Summary of Proposed Amendments
Phase 2
Weldale Street, Reading

Non-Material Amendment Application

For: Ropemaker Properties Ltd

This document summarises the changes made to the drawings associated with planning permission 170326 for the former Wickes Site, Reading

Proposed Lower Ground Floor Plan, 1:500 (3622-SC-0199EE)

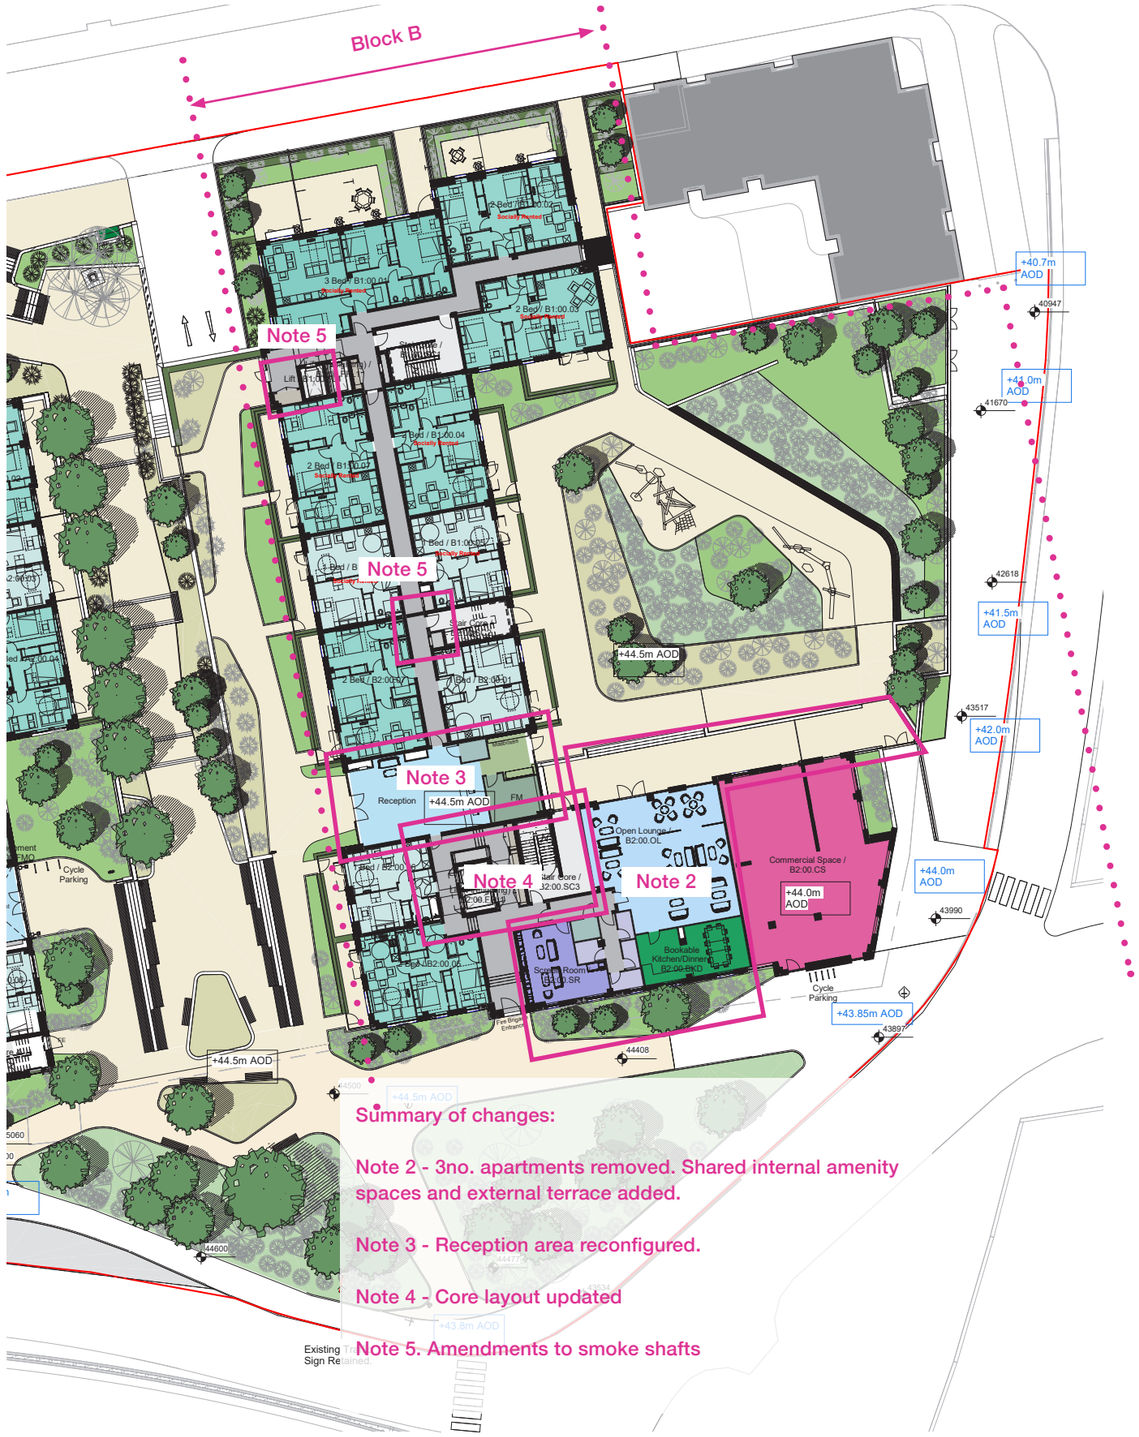
- Note 1 - As part of design development the commercial commercial plant area have been accomodated within the general plant space. Commericial refuse is to be located near the carpark entrance

- Due to new sprinkler recomendations for residentail building a new dedicated sprinkler tank has been added.
- CHP plant has been repaced with localised air source heat pumps requiring plant areas to be reconfigured.

- B1 Landscaping amended to suit updated levels.
- Carpark updated to suite layout changes, however carpark numbers to remain the same. Where space permits additional accessible spaces have been provieded.

- EV charging has been increased to provied on charger for every two spaces. these have been evenly distributed so all spaces can benifit from having access to a charger

- Note 1a - To ensure proper sprinkler cover to the below podium carpark a further additional sprinkler tank has been located below the predestrian ramp.

Proposed Ninth Floor Plan, 1:500 (3622-SC-0209R)

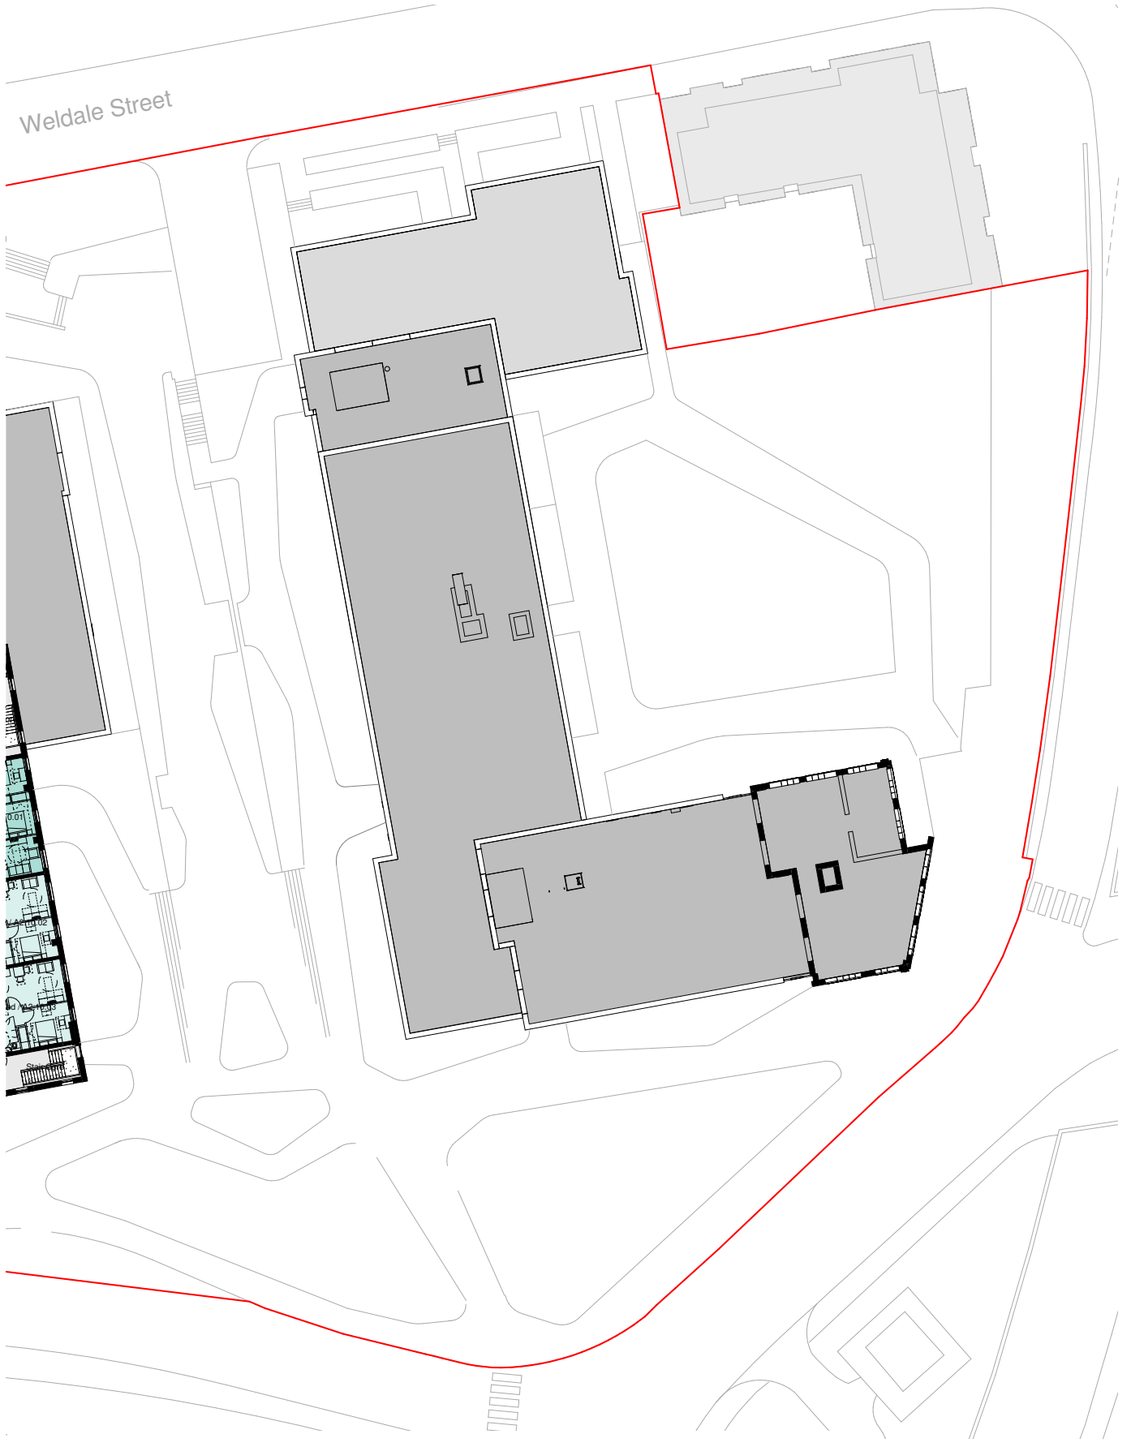
Note 4c - Core layout updated. 1 no. apartment layouts updated to suit.

Note 5 - Amendments to smoke shafts

Note 7 - Note 7 - Blue/Green roof to all roof areas. Blue/Green roof shown indicatively, detailed Drainage Strategy for Blocks B1 & B2 to be submitted to discharge the remainder of Condition 34 + Introduction of PV panels located as indicated

Extract from proposed Site Elevation South, 1:200 (3622SC-0300G),

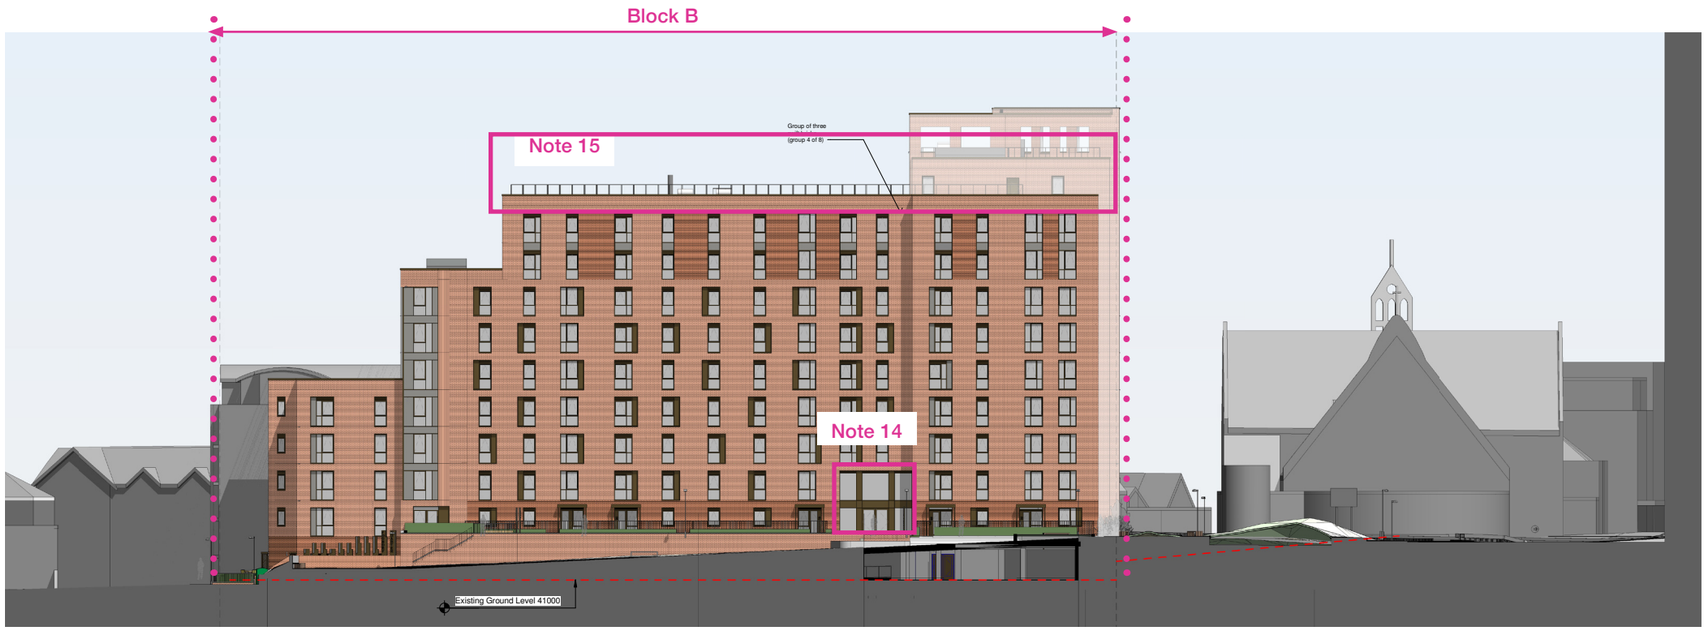
Arrangement of corner glazing updated to align with fire brigade access requirments

PVs + Edge Protection to roof areas

Fenetration updated to rationalize windows and allow for reception back of house area

PVs + Edge Protection to roof areas

windows rationalised to suit fire escape half landdings

Fenetration updated to suit updated reception area

Proposed Extract of B1/B2 West Elevation, (Drawing 3622-SC-0405F)

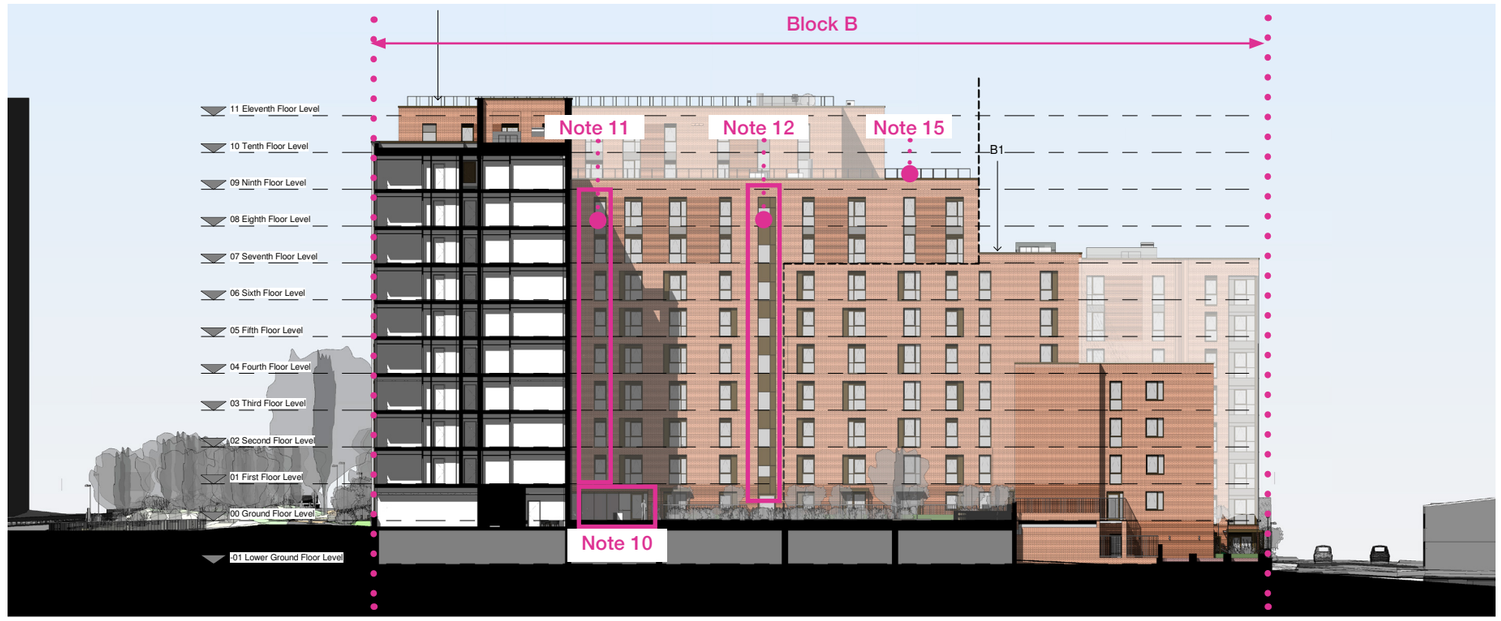
Note 14- Fenestration updated for double height reception space.

Note 15- PVs + Edge Protection to roof areas

B1 South Elevation, 1:500 (Drawing 3622-B1-0301D)

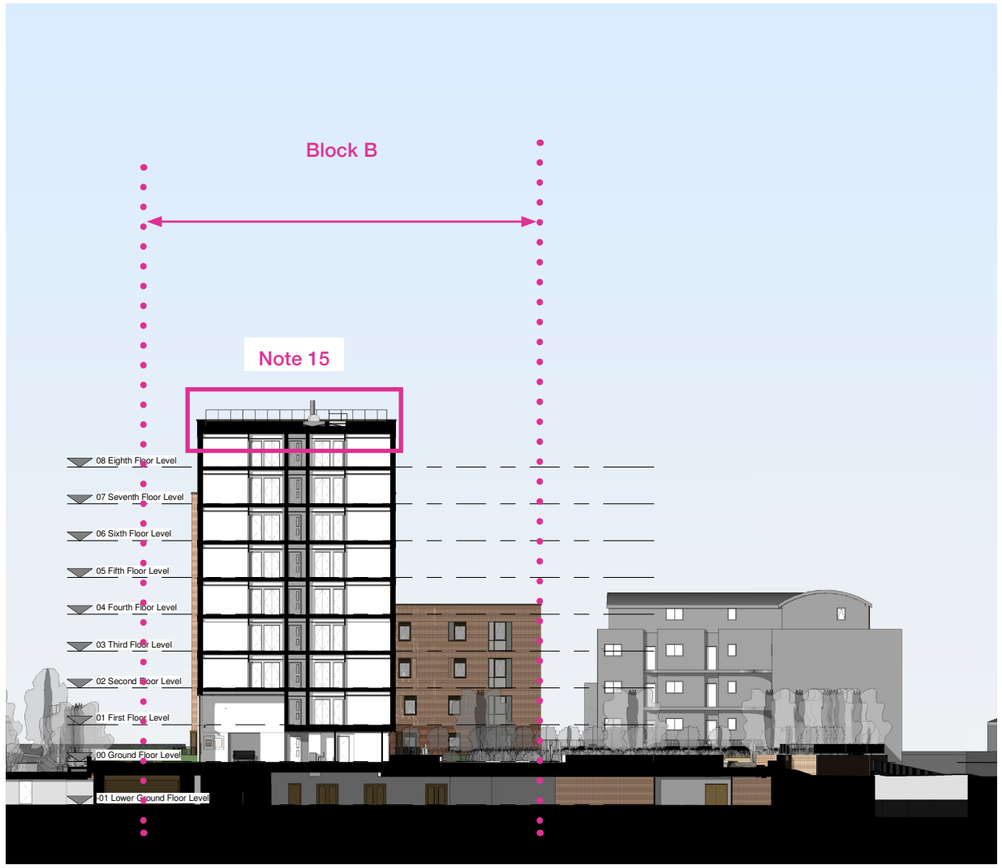
Note 15- PVs + Edge Protection to roof areas

Proposed Site Elevation - South, 1:500 (Drawing 3622-SC-0300G)

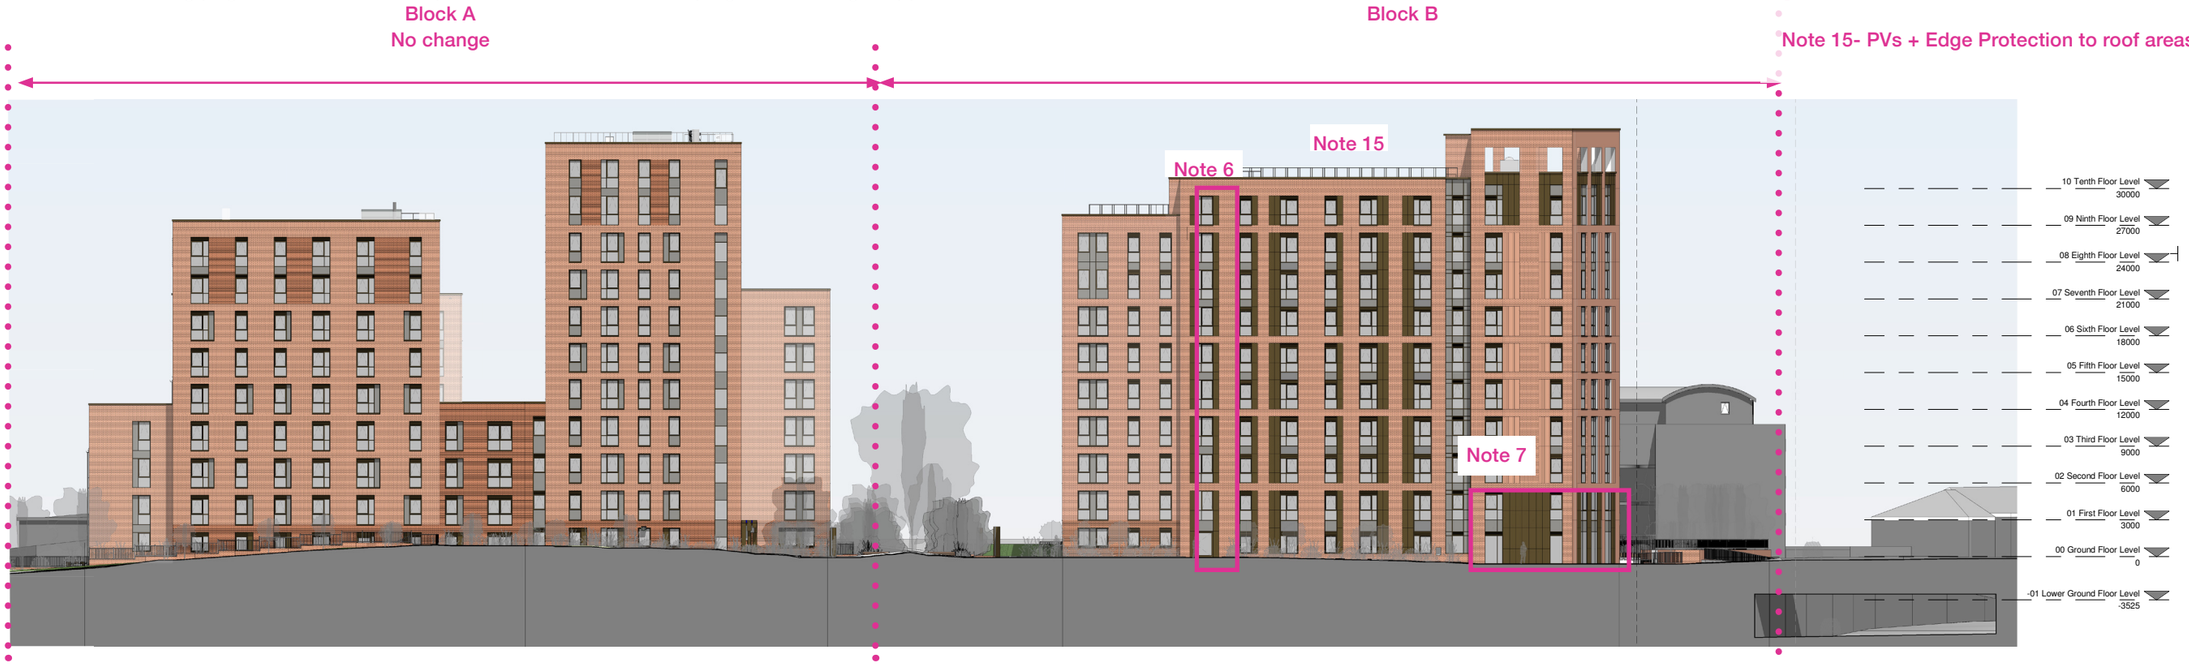
Note 6- Curtain wall containing Firemans entrance updated to ensure mullion position consistancy up the buildings facade.

Note 7 -- Fenetration updated to suit updated ground floor level. .

Note 15- PVs + Edge Protection to roof areas

Proposed Site Elevation - North, 1:500 (Drawing 3622-SC-0302K)

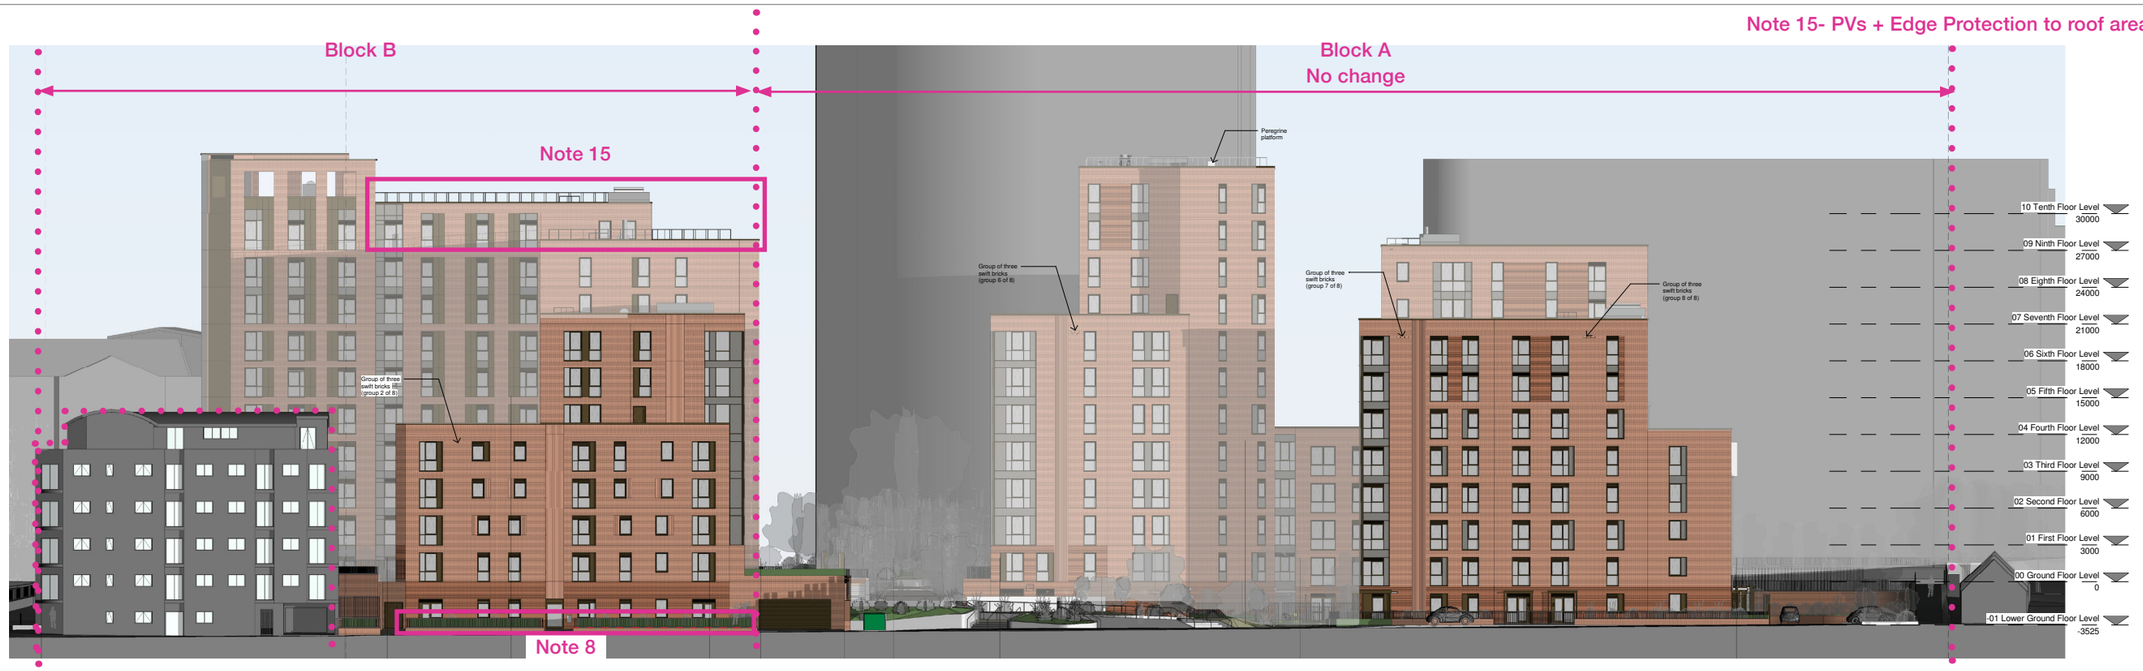
Note 8 - Boundary walls and hard landscaping to B1 North Elevation updated to suit levels.

Note 15- PVs + Edge Protection to roof areas

Proposed Site Elevation - East, 1:500 (Drawing 3622-SC-0303F

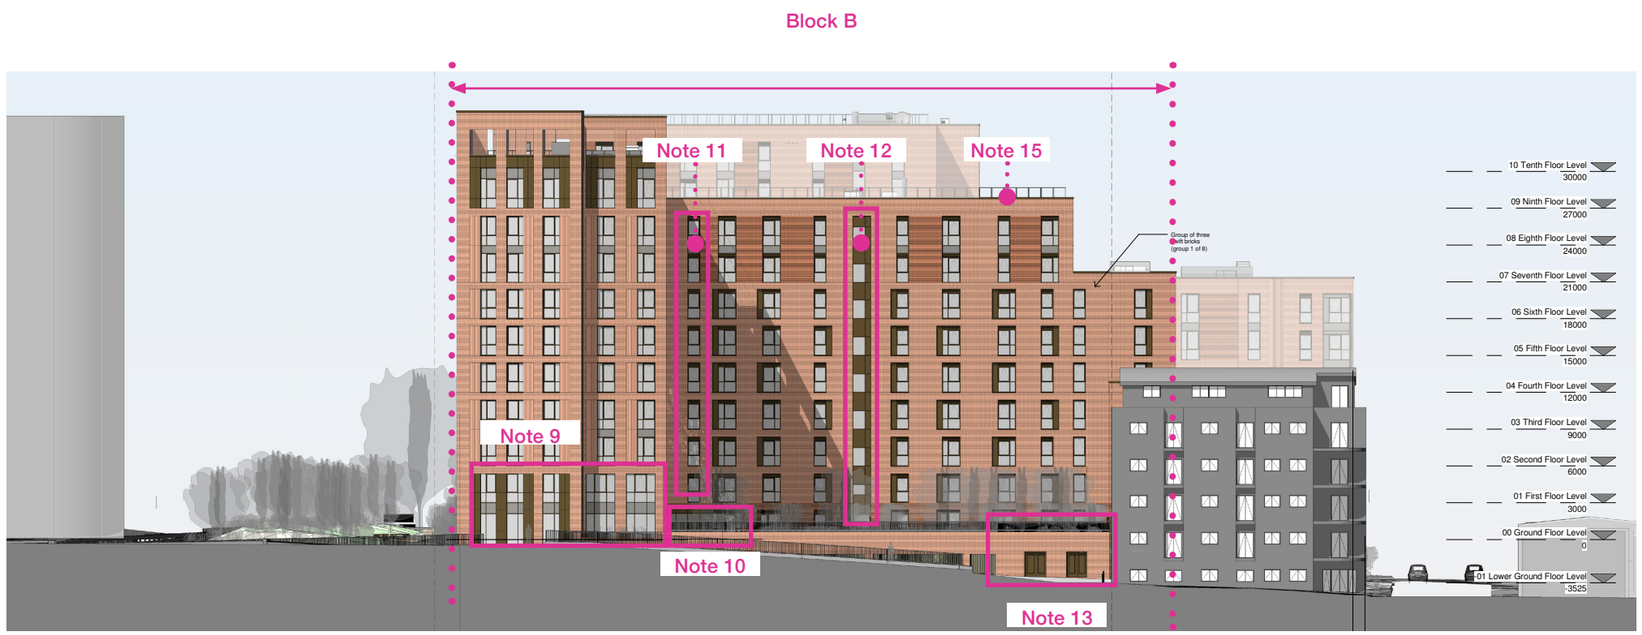
Note 9 - Fenetration updated to suit updated levels and new amenity areas

Note 10 - Fenetration updated to suit updated reception area

Note 11 - Fenetration updated to rationalize windows and allow for reception back of house area

Note 12 - Fenetration updated to suit reconfigured escape stair

Note 13- Substation doors updated In line with UKPS requirments

Note 15- PVs + Edge Protection to roof areas
